# FINDINGS OF FACT AND CONCLUSIONS

*RUSH LINE BUS RAPID TRANSIT PROJECT ENVIRONMENTAL ASSESSMENT*

OCTOBER 2021

14

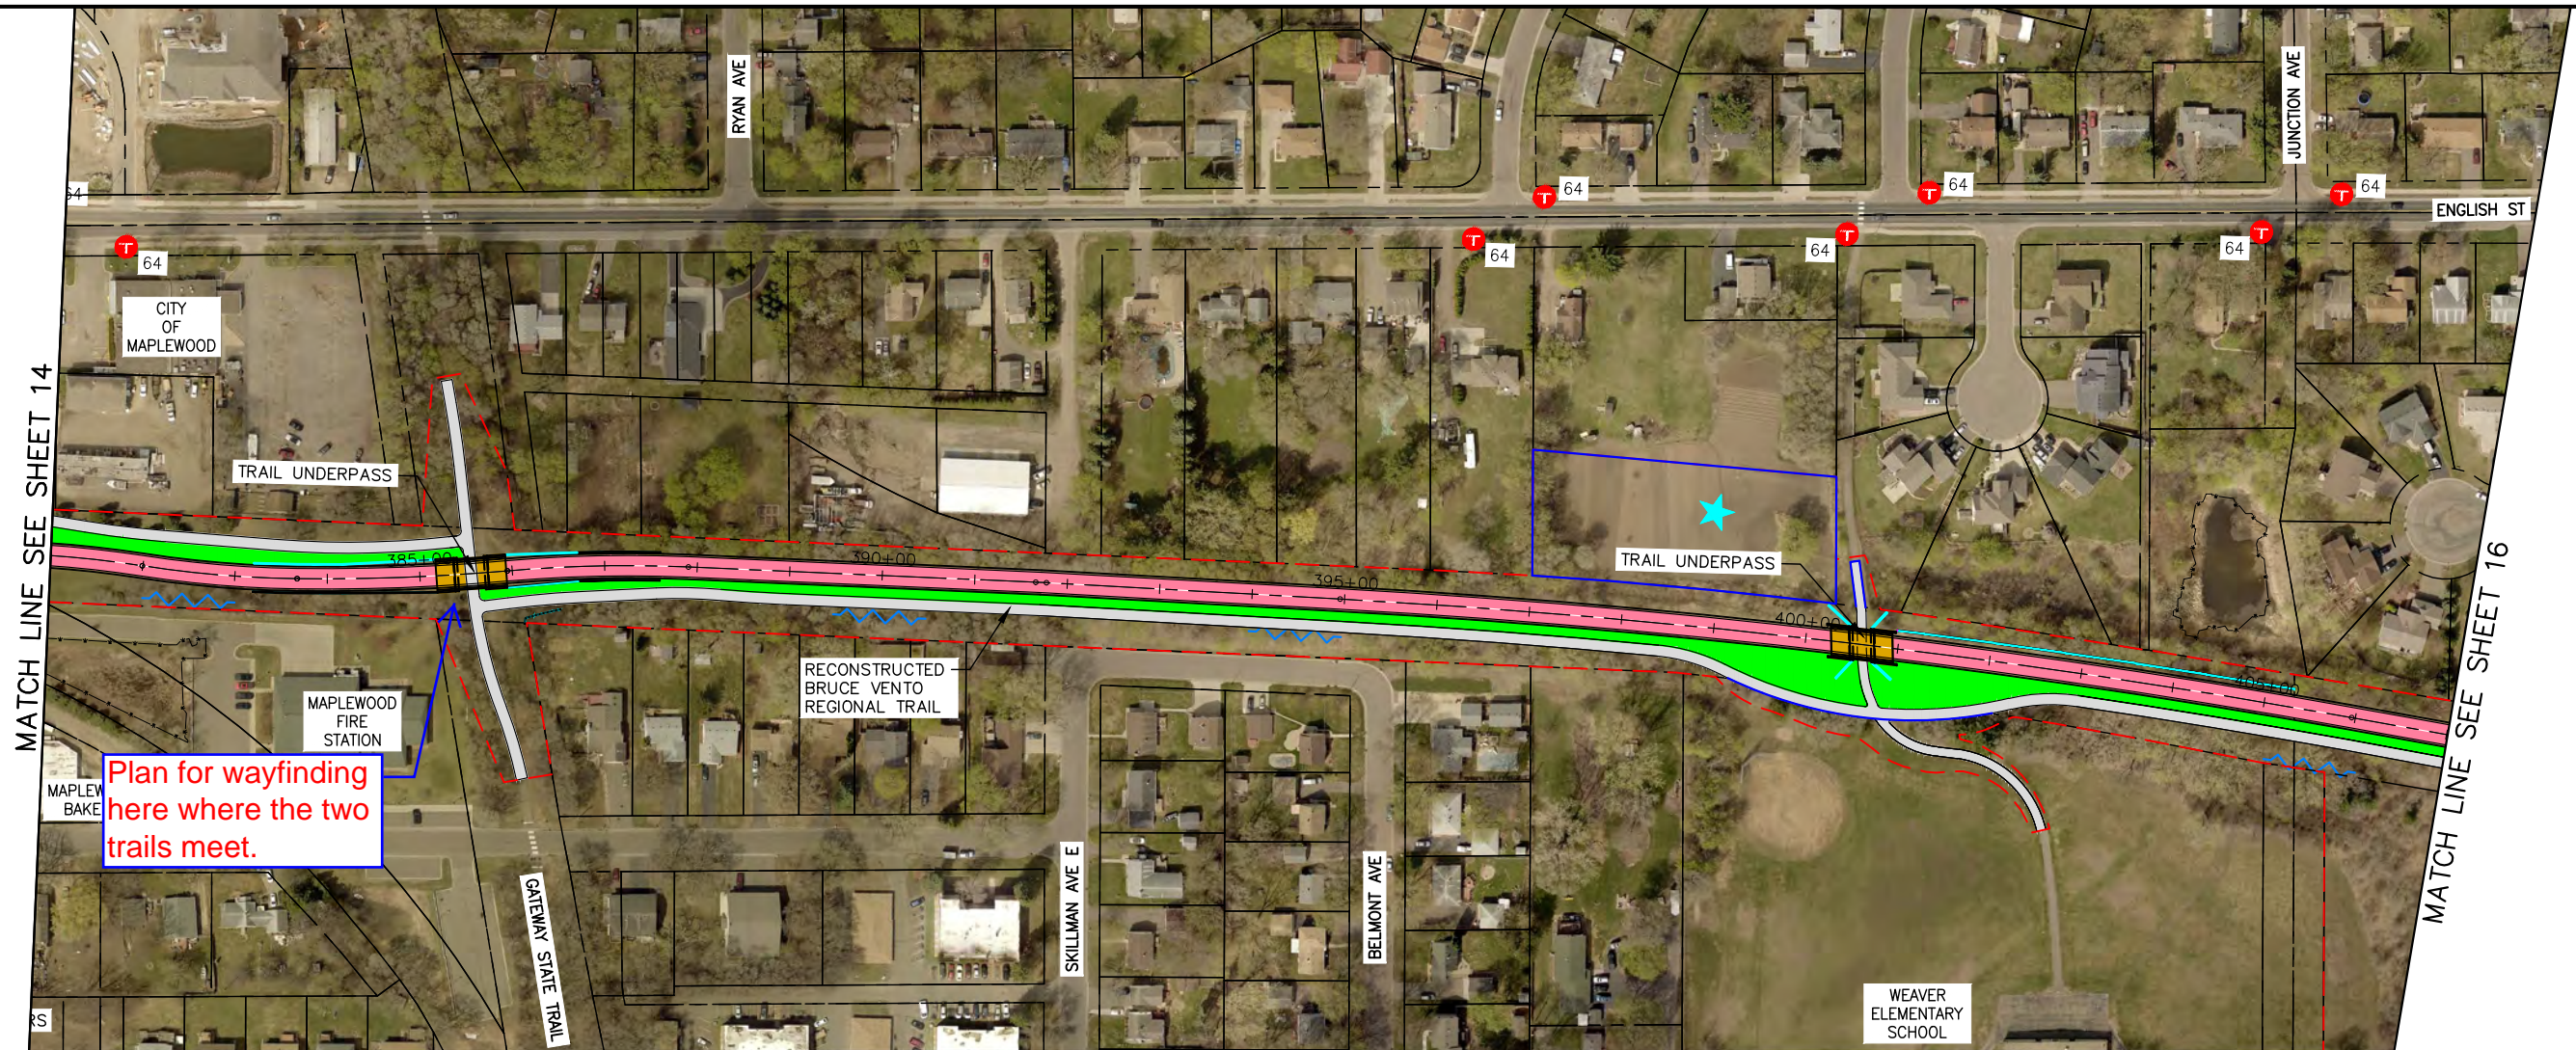
<p>Sheet 14:</p> <ul style="list-style-type: none"> <li>• May be wise to include an RRFB here to help bikes and peds cross Frost Ave. Motorists exiting the roundabout may not yield to people at the crosswalk.</li> </ul>	<p>A full signal is proposed at this location and is anticipated to have an accessible pedestrian signal. Signal design will be determined as engineering advances.</p>

SHEET NO.  
15  
OF  
83

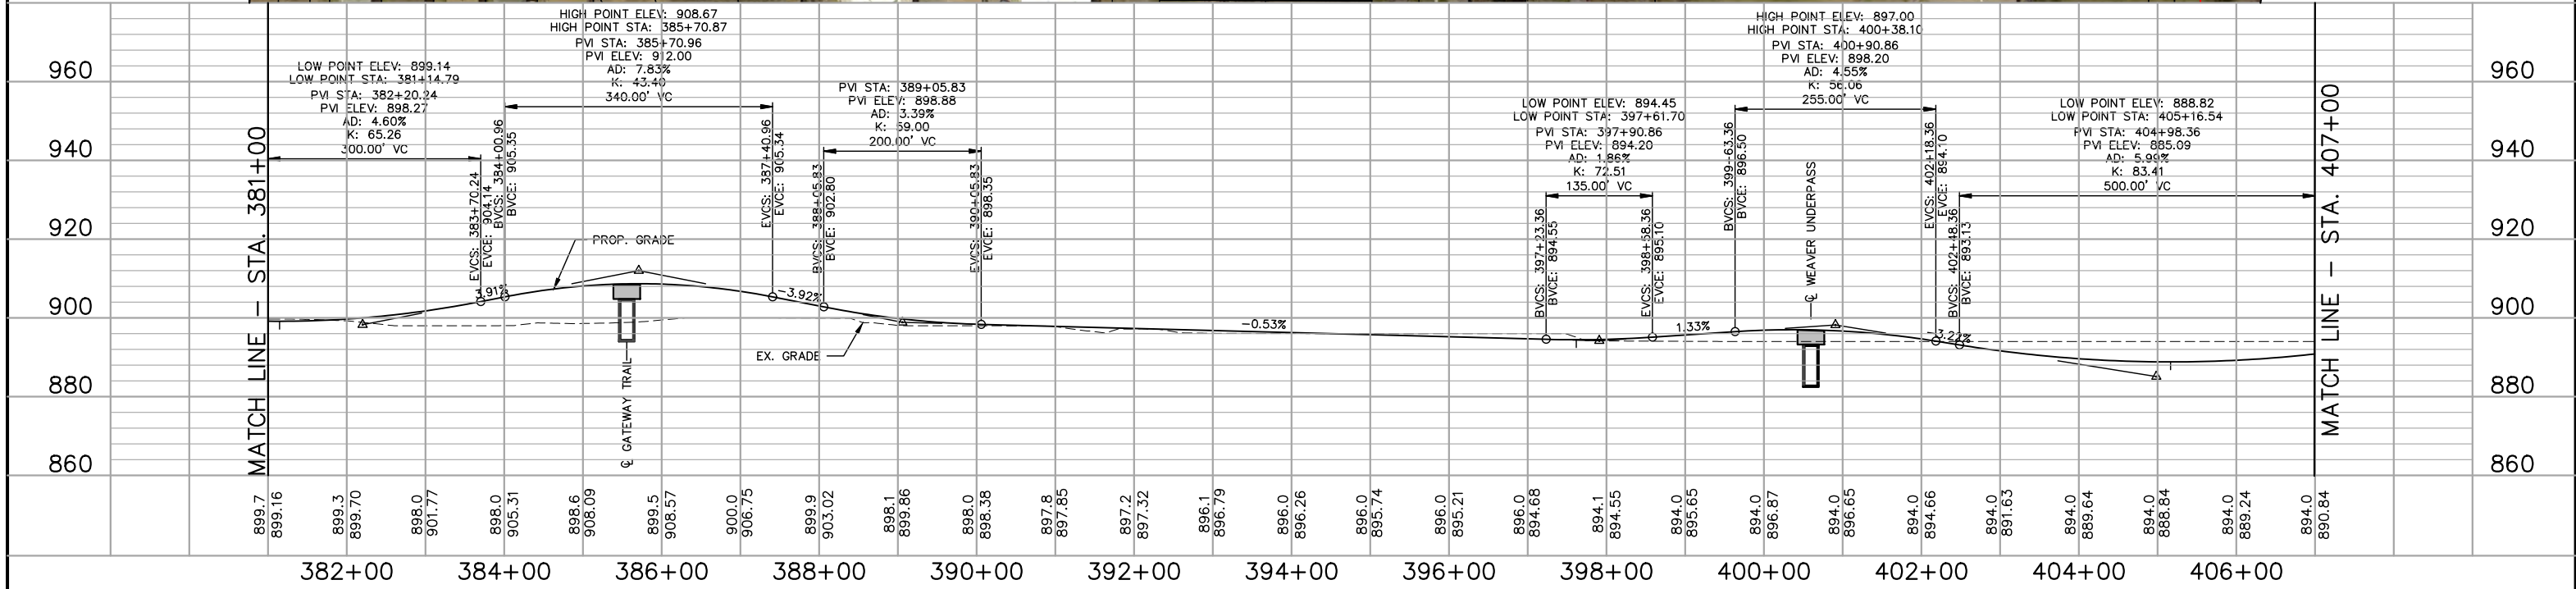
Comment	Response
Sheet 15: <ul style="list-style-type: none"> <li>Plan for wayfinding here where the two trails meet.</li> </ul>	Wayfinding signage will be determined as design progresses.

Plan for wayfinding  
here where the two  
trails meet.

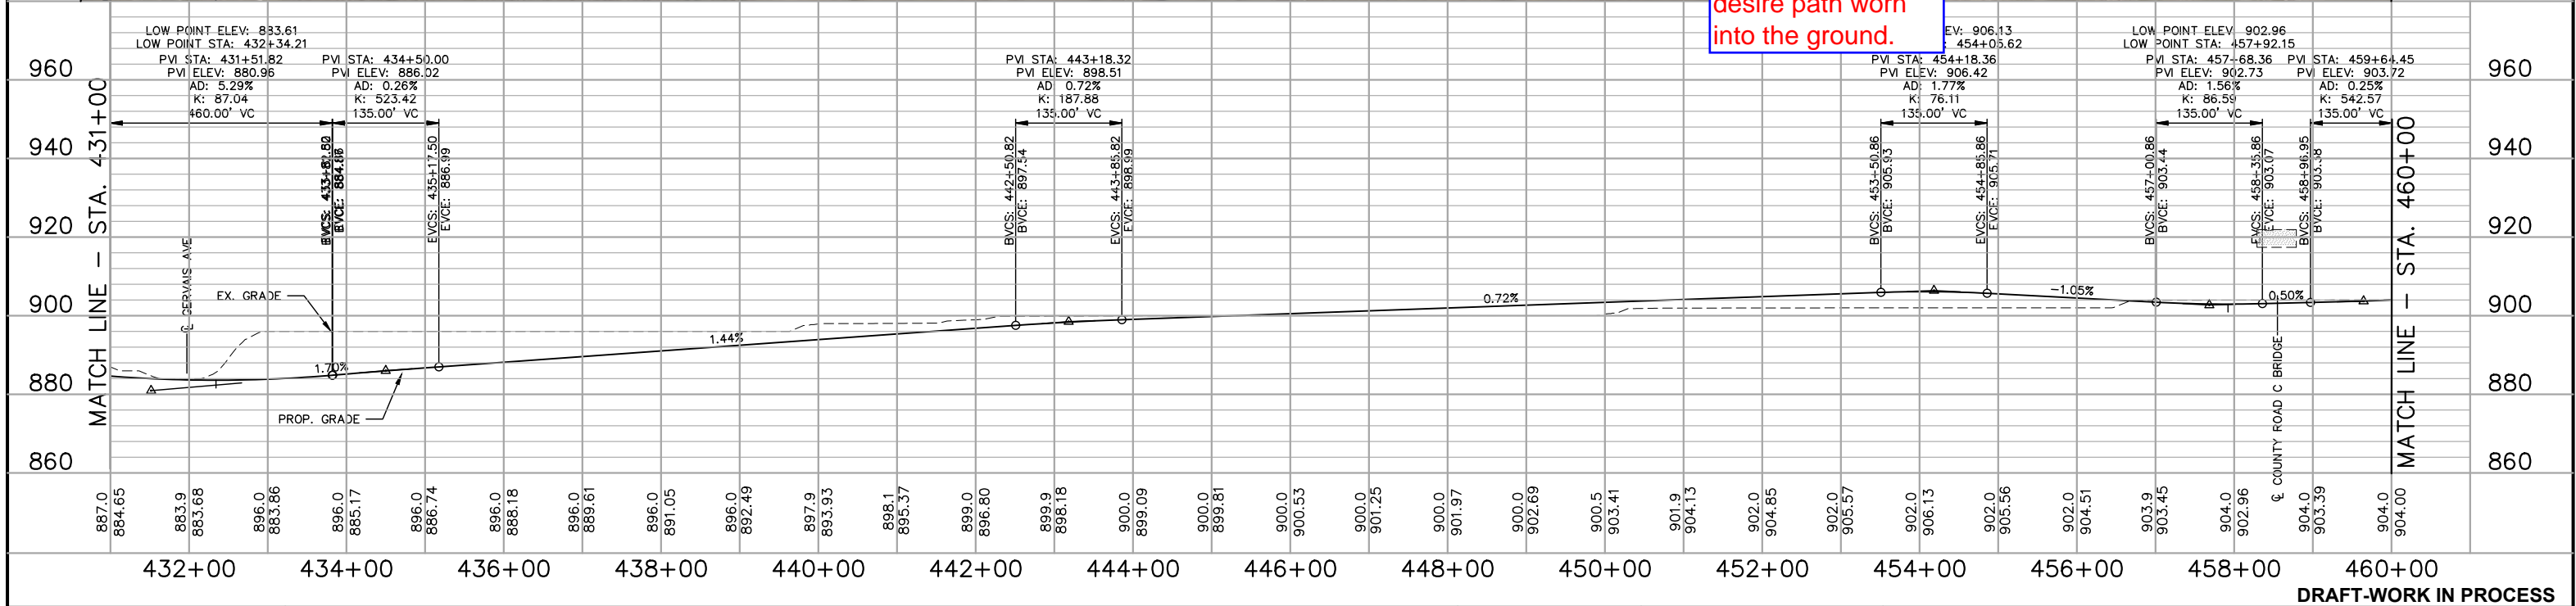
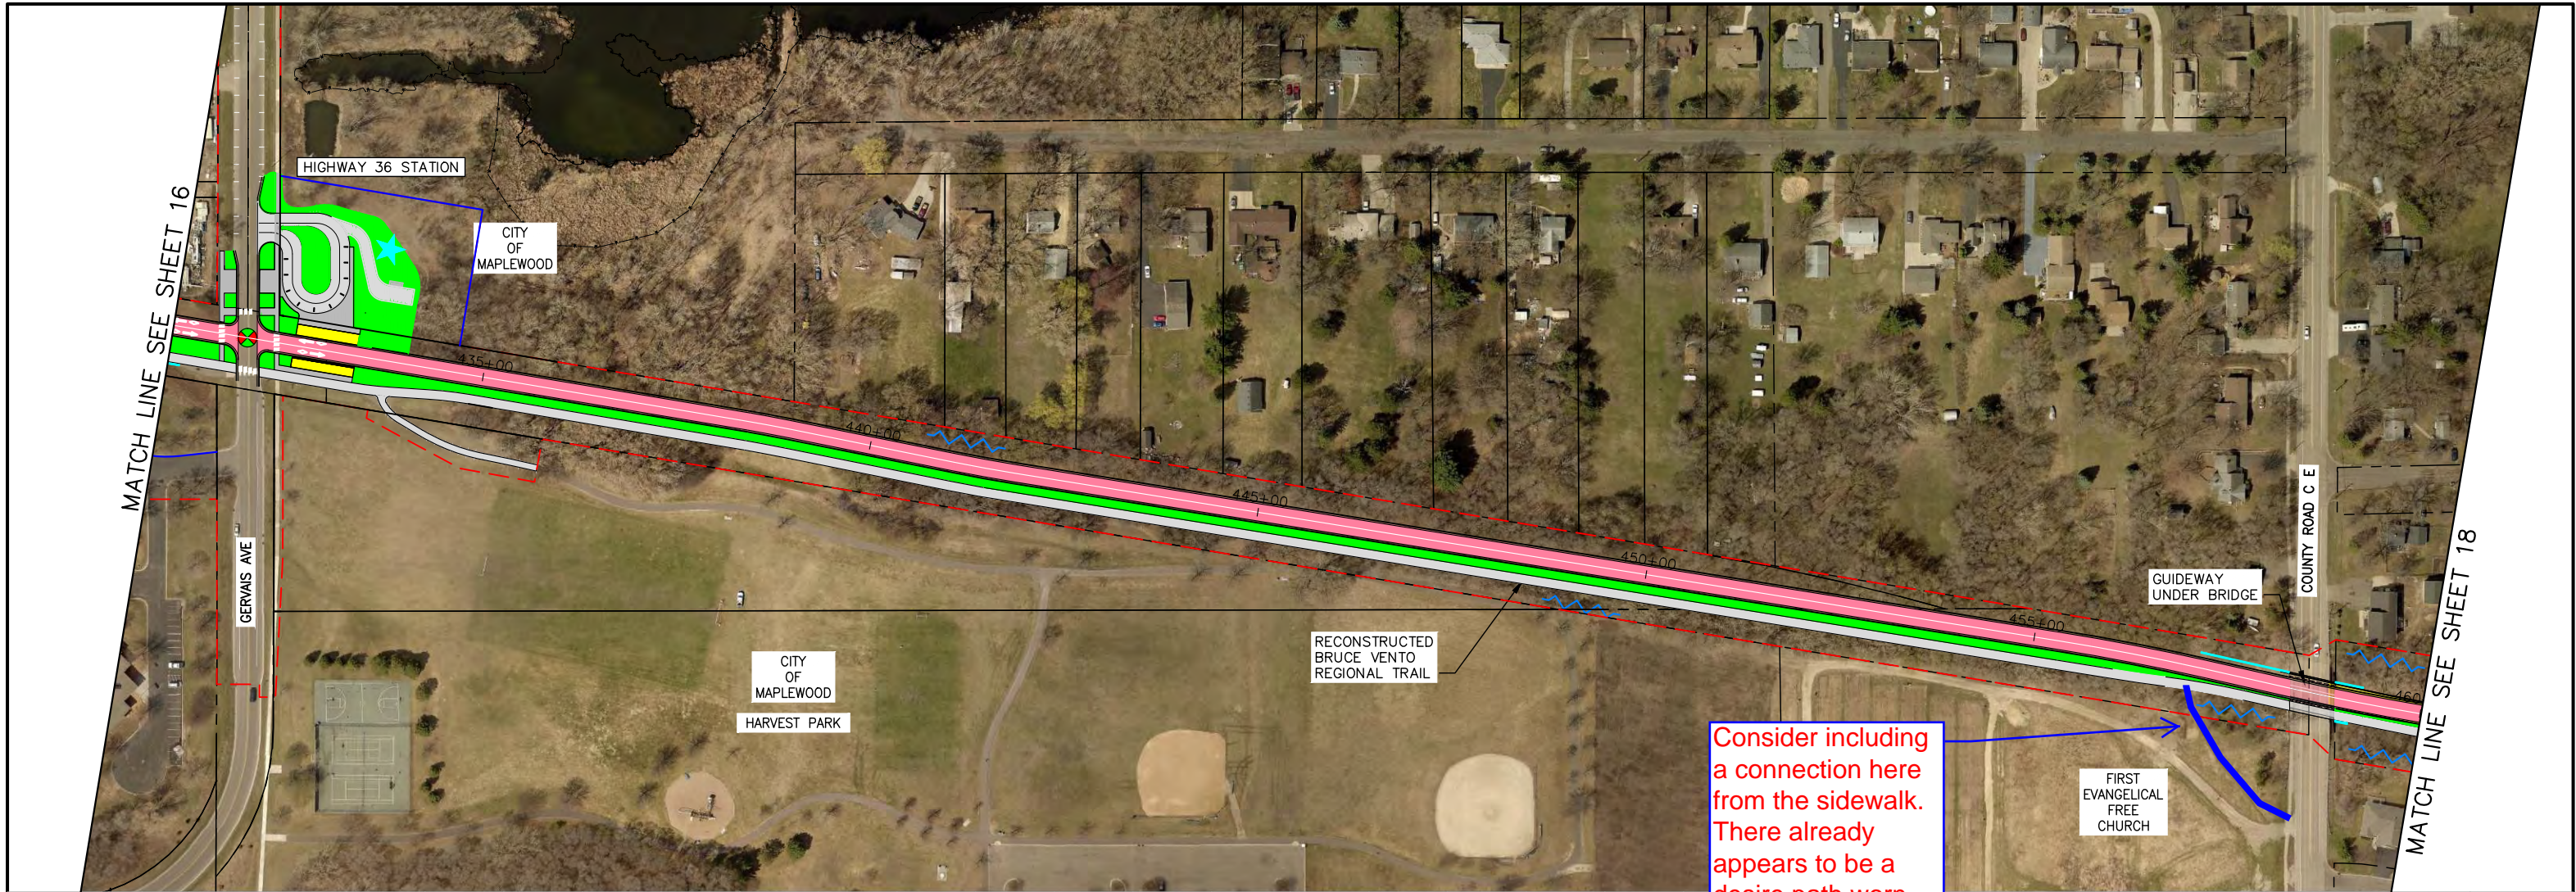
Sheet 17A: <ul style="list-style-type: none"> <li>Consider including a connection here from the sidewalk. There already appears to be a desire path worn into the ground.</li> </ul>	The noted location is on private property. Project staff will work with adjacent property owners and the city of Maplewood on local pedestrian connections as engineering advances.

Consider including a connection here from the sidewalk. There already appears to be a desire path worn into the ground.

21  
OF  
83

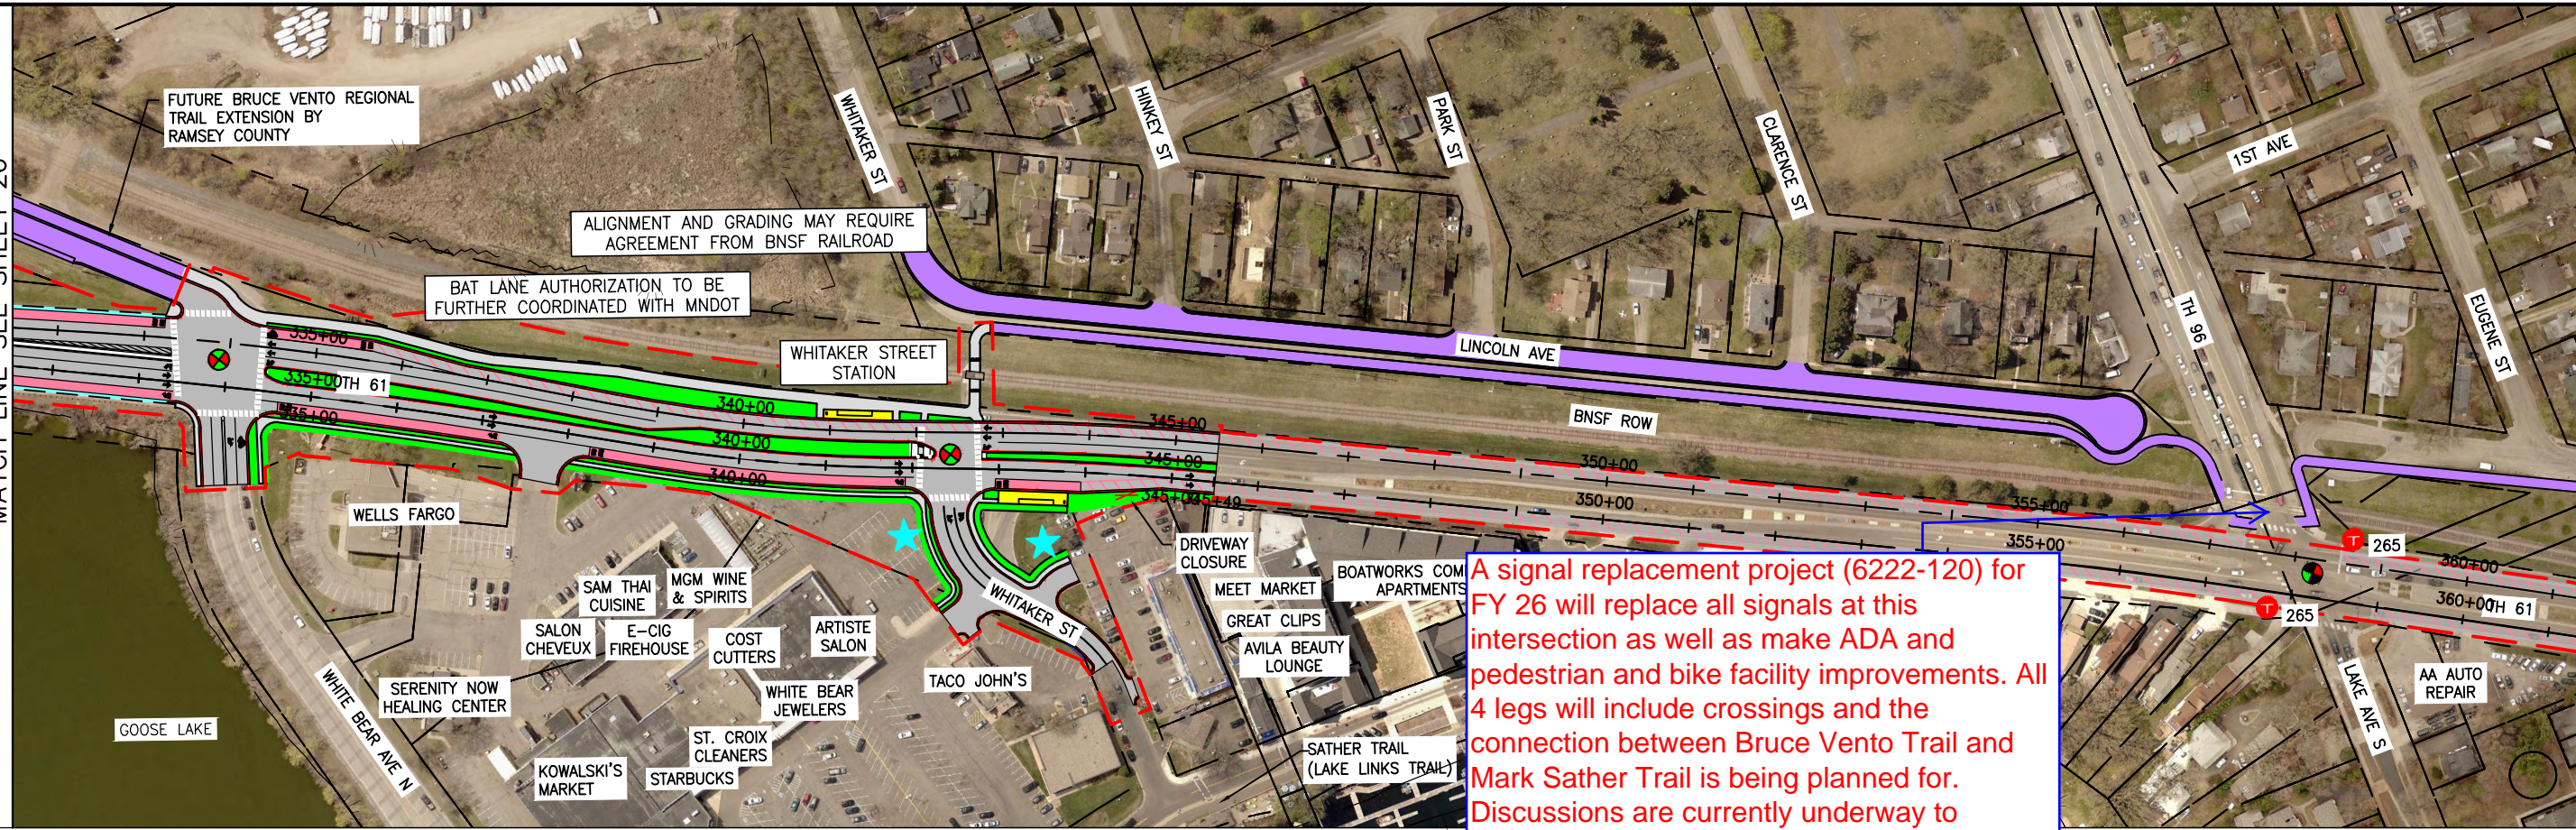
Sheet 21: <ul style="list-style-type: none"> <li>Consider ped refuge in between traffic lane and dedicated bus lane.</li> </ul>	Right-of-way and design vehicle turning movement constraints limit the space available in this location and do not allow for a pedestrian refuge.
